HISTORIC AND DESIGN REVIEW COMMISSION

April 07, 2021

HDRC CASE NO: 2021-108
ADDRESS: 831 LAMAR ST
LEGAL DESCRIPTION: NCB 1368 BLK 5 LOT 21
ZONING: R-6, H
CITY COUNCIL DIST.: 2
DISTRICT: Dignowity Hill Historic District
APPLICANT: Ron HILL/HILL RONNIE K
OWNER: Ron HILL/HILL RONNIE K
TYPE OF WORK: Construction of a new accessory structure
APPLICATION RECEIVED: March 02, 2021
60-DAY REVIEW: Not applicable due to City Council Emergency Orders
CASE MANAGER: Huy Pham

The applicant is requesting a Certificate of Appropriateness for approval to construct a 450 square foot rear accessory structure in the northwest corner in the rear yard of the property.

3 FRONT ELEVATION
Scale: 1/4" = 1'-0"

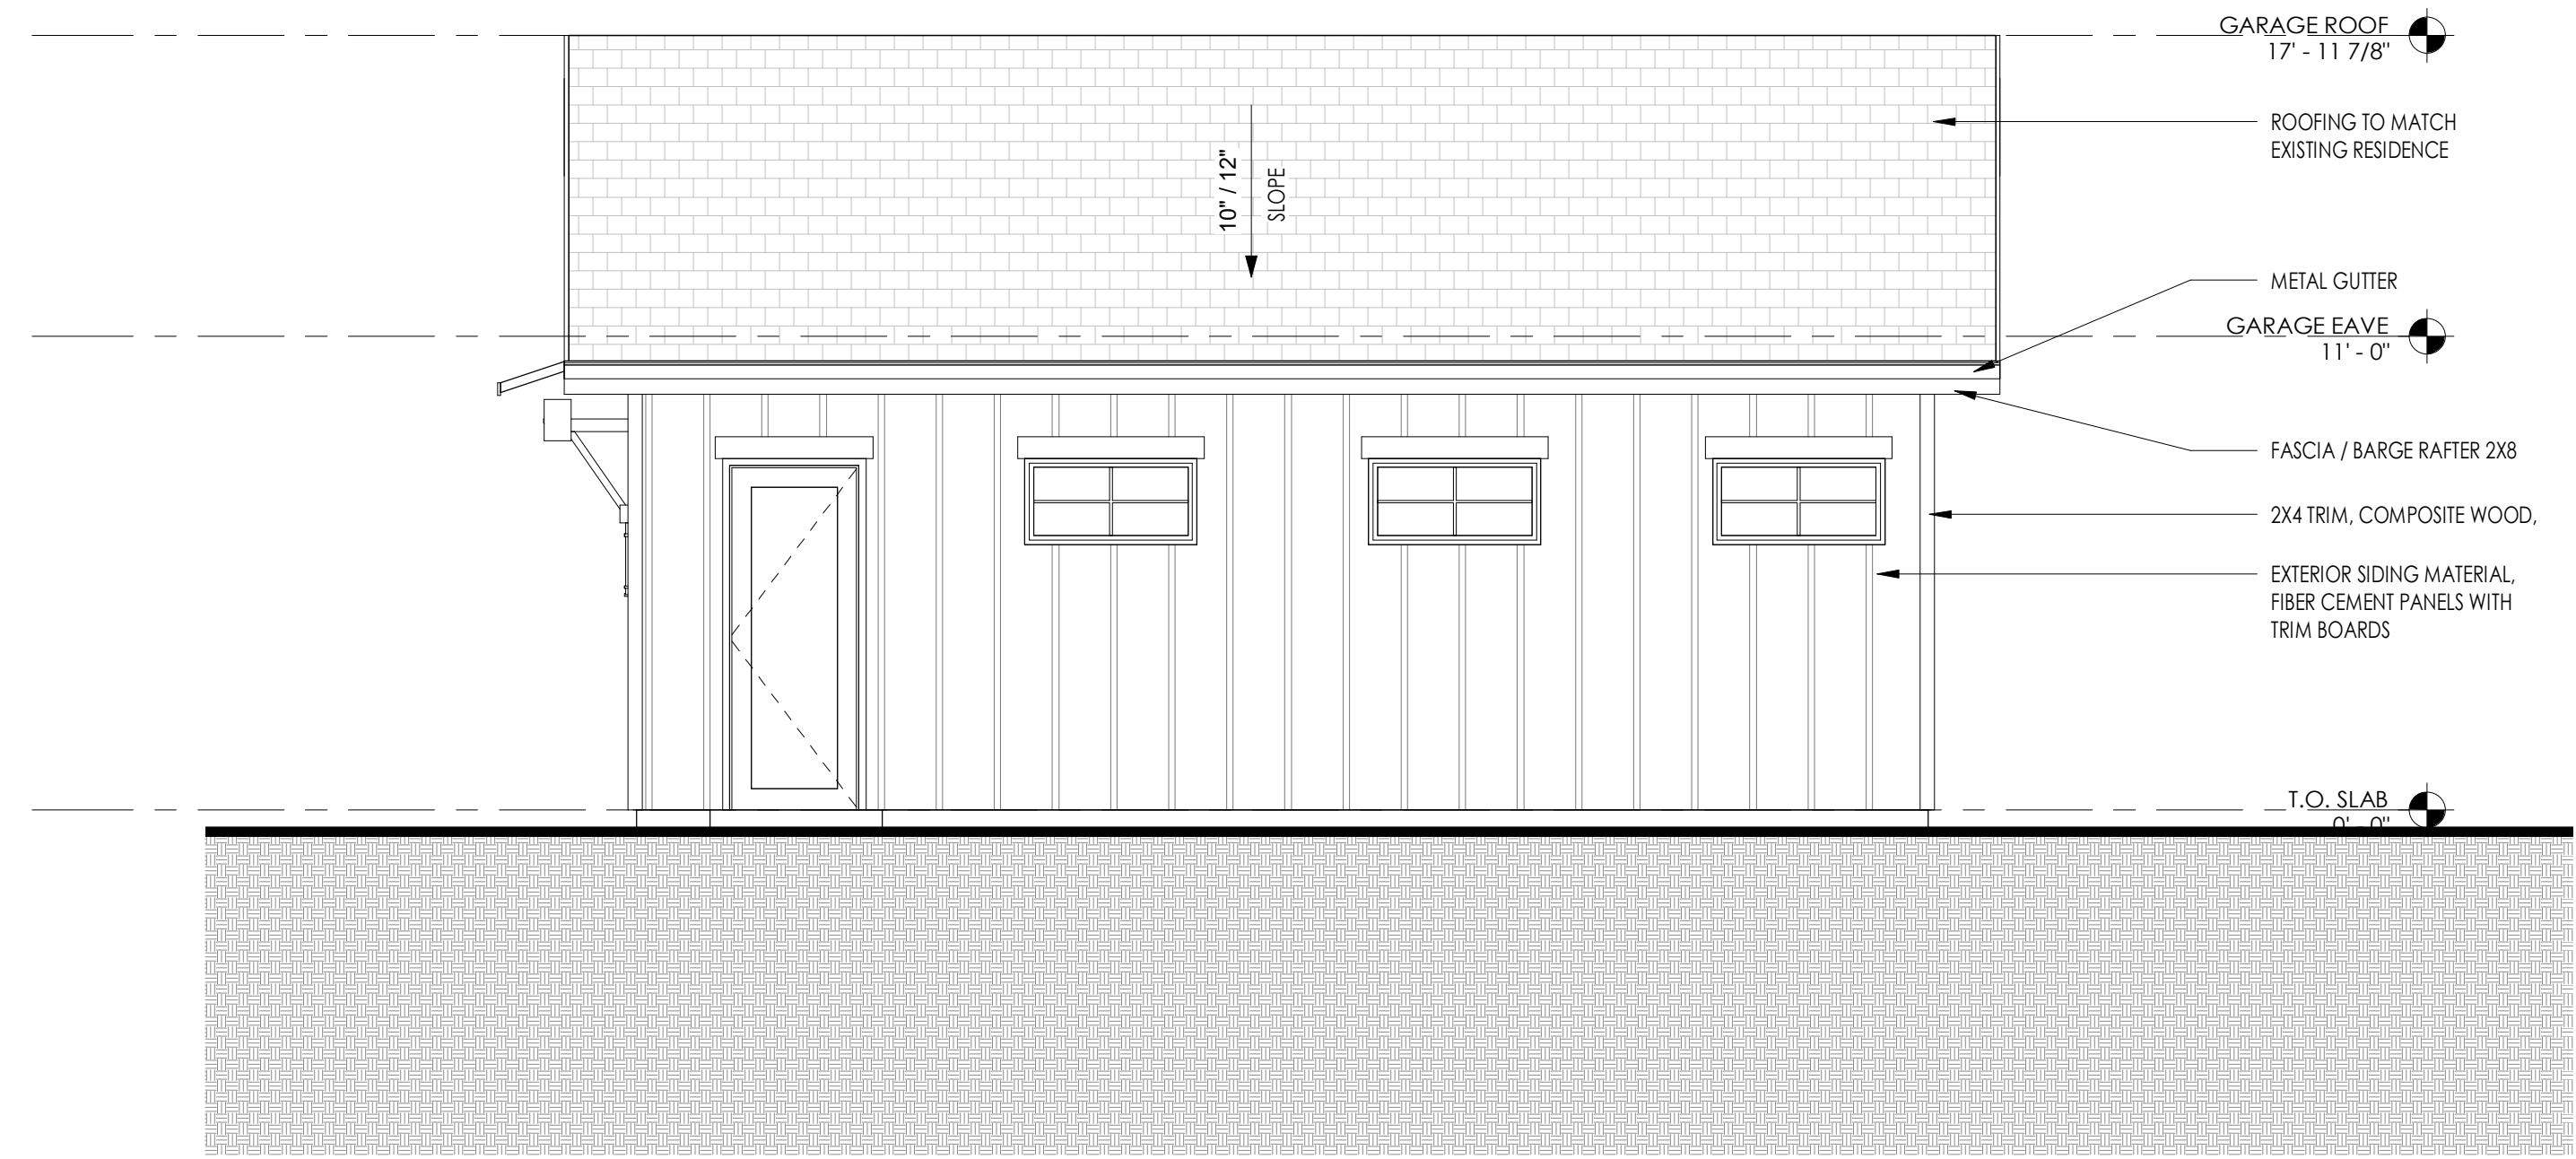
- c. MASSING AND FORM – Per the Guidelines for New Construction 5.A.i., applicants should design new garages and outbuildings to be visually subordinate to the principal historic structure in terms of their height, massing, and form. The application has proposed a gable roof with a shed roof over the front facing garage door – with a maximum height of 18’ for the one-story garage. Staff finds the proposed massing and form appropriate.

- e. CHARACTER – Per the Guidelines for New Construction 5.A.iii., applicants should relate new garages and outbuildings to the period of construction of the principal building on the lot through the use of complementary materials and simplified architectural details. The applicant has proposed to use board-and-batten siding, shingle roofing on the gable and metal roofing on the shed overhang, and simple doors and windows. Staff finds the architectural details appropriate.

1 GARAGE FIRST FLOOR PLAN
Scale: 1/4" = 1'-0"

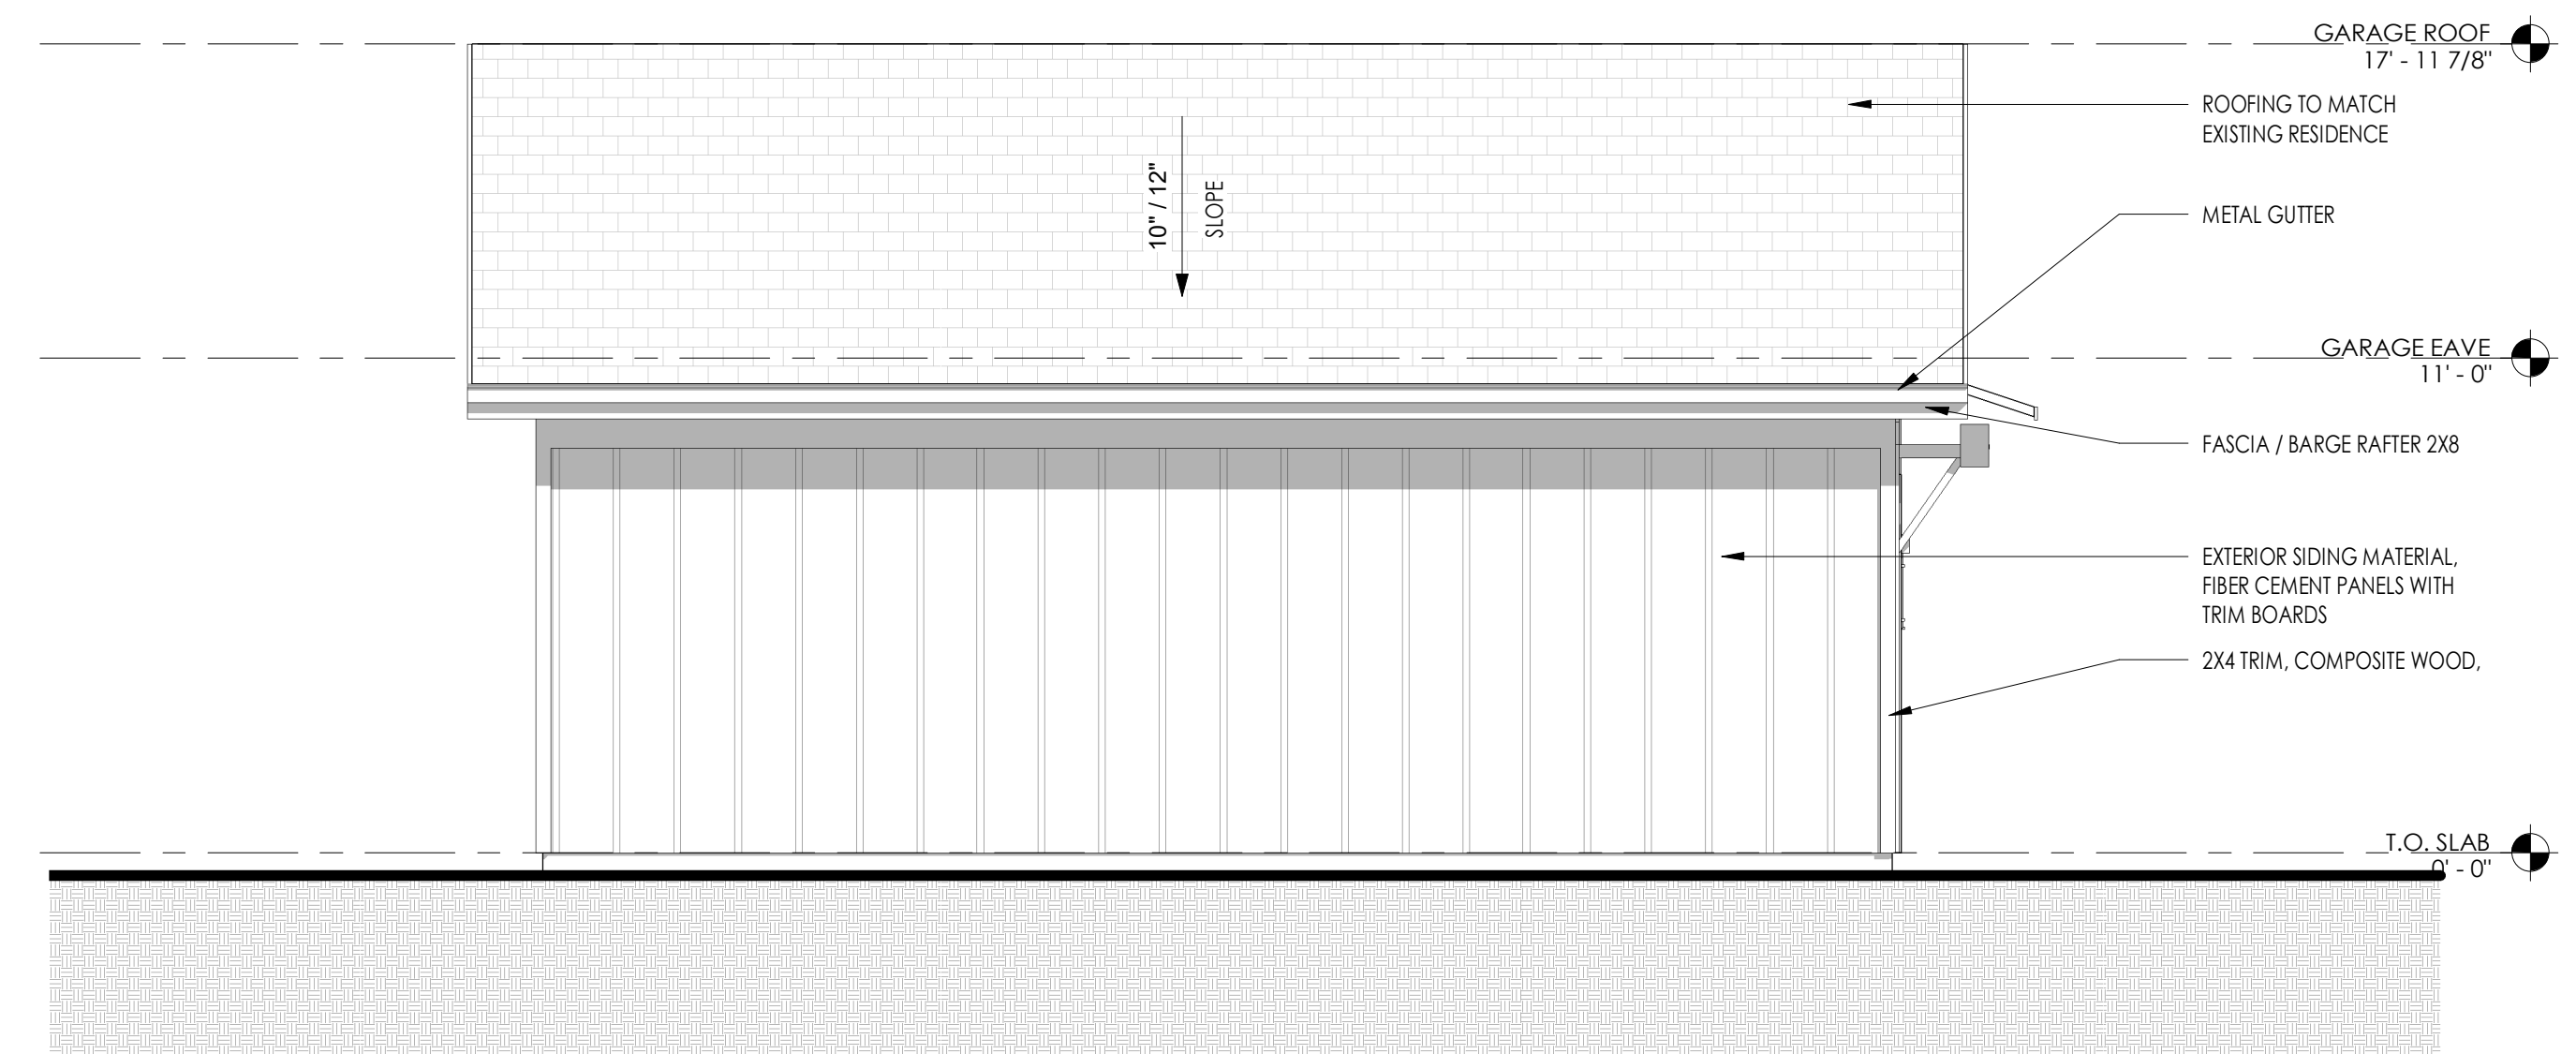
- d. BUILDING SIZE – Per the Guidelines for New Construction 5.A.ii., new outbuildings should be no larger in plan than 40 percent of the principal historic structure footprint. The applicant has proposed a 450 square foot accessory structure to the rear of the 1578 square foot primary residence. Staff finds the proposed footprint

- f. WINDOWS AND DOORS – Per the Guidelines for New Construction 5.A.iv., applicants should design window and door openings to be similar to those found on historic garages or outbuildings in the district or on the principle historic structure in terms of their spacing and proportions. The applicant has proposed a single width front garage door in a simple 8-panel design and interior facing pedestrian door with 3 windows. Staff finds proposed fenestration a pattern appropriate, with the stipulation that the final door and window products adhere to the Standard Specifications for Windows in New Construction and are submitted to staff prior to purchase and installation.

Staff recommends approval based on findings b through h with the stipulation that final door and window products adhere to the *Standard Specifications for Windows in New Construction* and are submitted to staff prior to purchase and installation.

PLOT PLAN
FOR BUILDING PERMITS

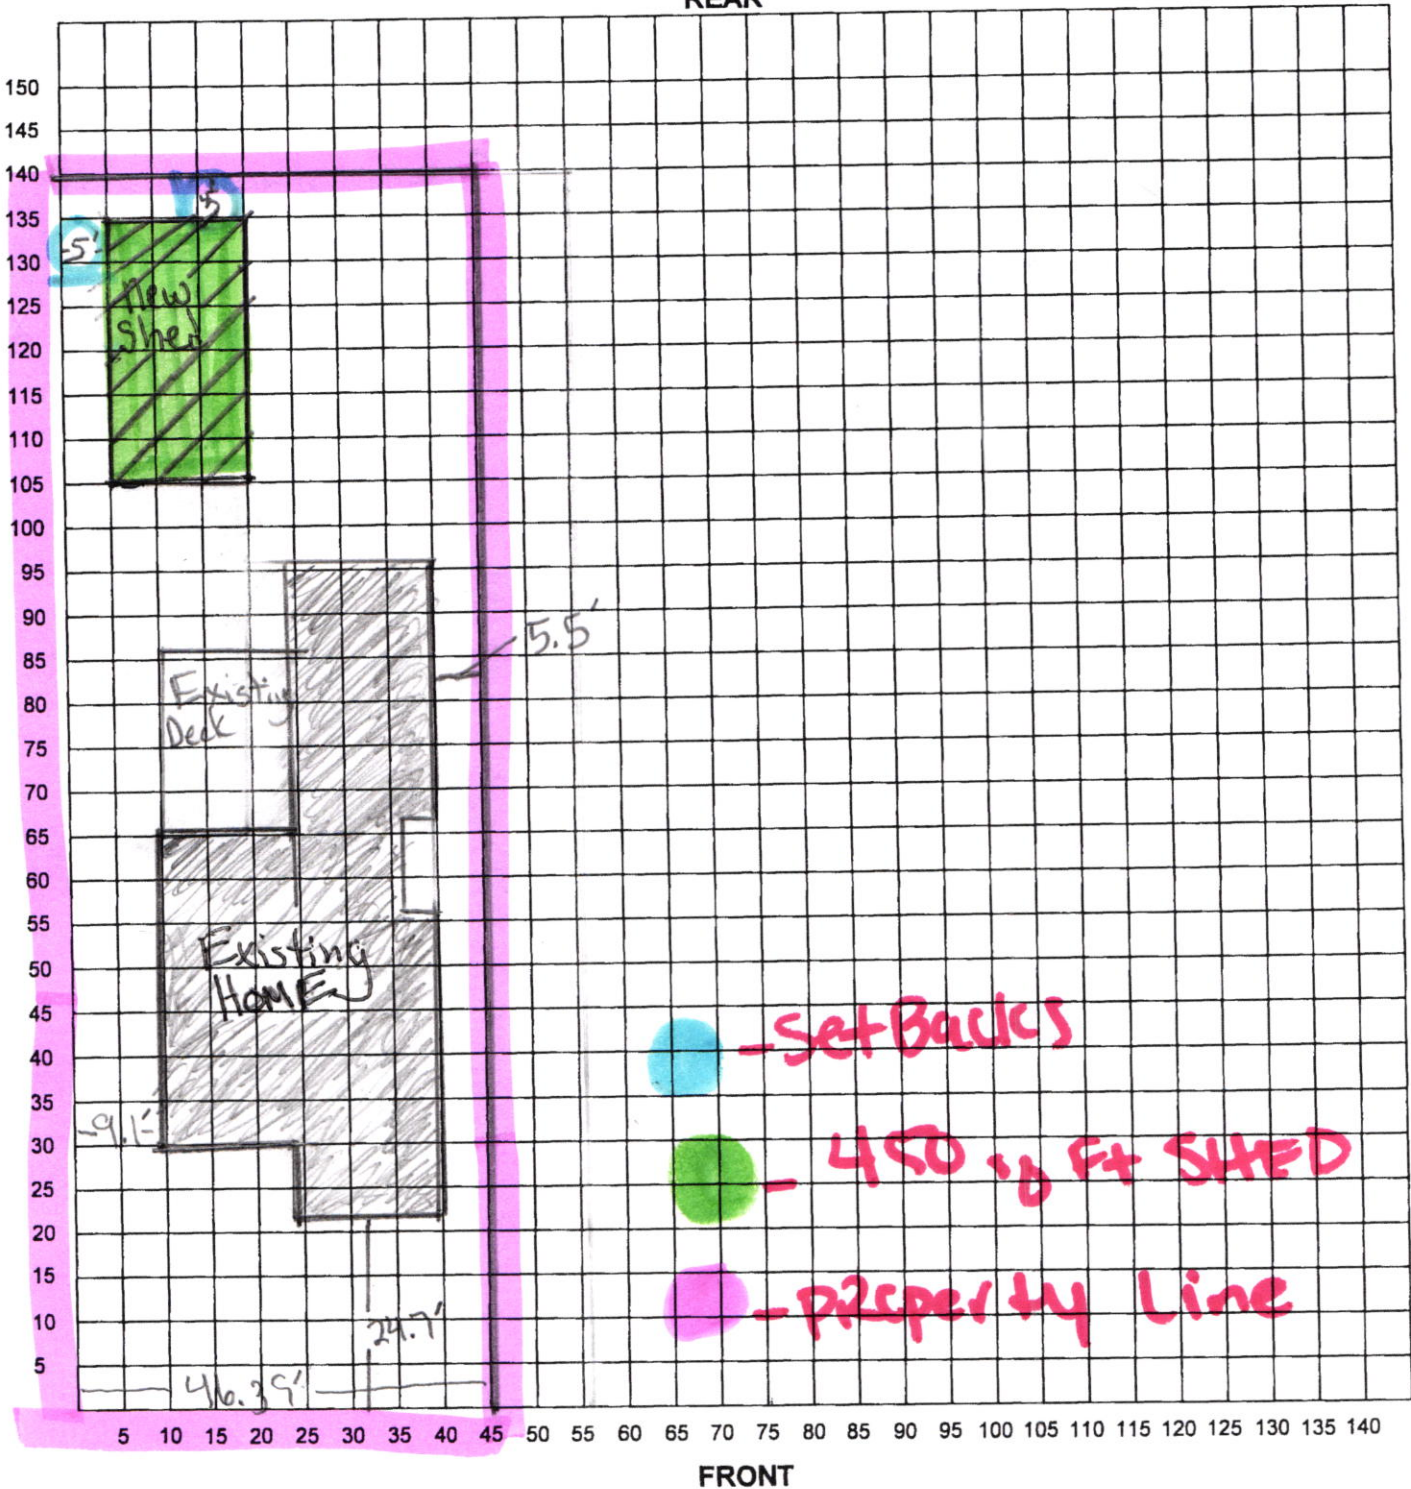
- g. ORIENTATION – Per the Guidelines for New Construction 5.B.i., applicants should match the predominant garage orientation found along the block. The applicant has proposed to locate the structure at the northwest corner in the rear yard at the end of the driveway. Staff finds the proposed placement is consistent with the historic development pattern.

- h. SETBACK – Per the Guidelines for New Construction 5.B.ii., applicants should follow historic setback pattern of similar structures along the streetscape or district for new garages and outbuildings. The applicant has proposed a 5-foot set back from the side and rear property line. Staff finds the proposed setback appropriate.
